Access Compliance Report

Public Rights-of-Way

(Pedestrian Signals)

Intersection ID: N/A	Main Street:	Cross Street: N/A	Location: N/A
ADA ID: 121B998182E0	Signal Type: Two Push Buttons-Non APS	Overall Compliance: No	Severity Score: BTN 1:N/A BTN 2: N/A No BTN: N/A
Codes/Mitigation Info/Possible Solution		Field Measurements/Component Compliance

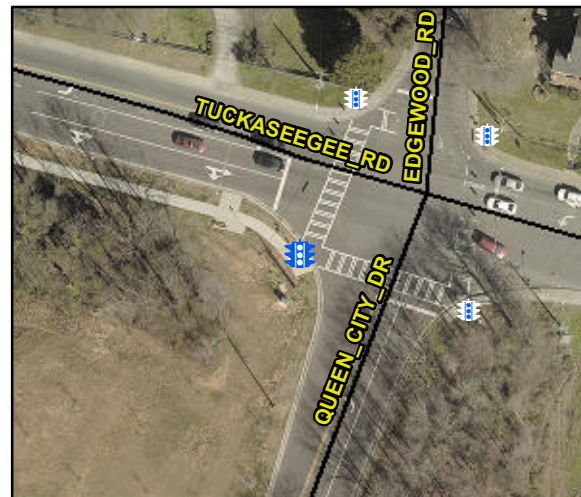
Possible Solutions: Remove and Replace Clear Space.

PROW/ADA: R404.2, R404.3, R404.7.2
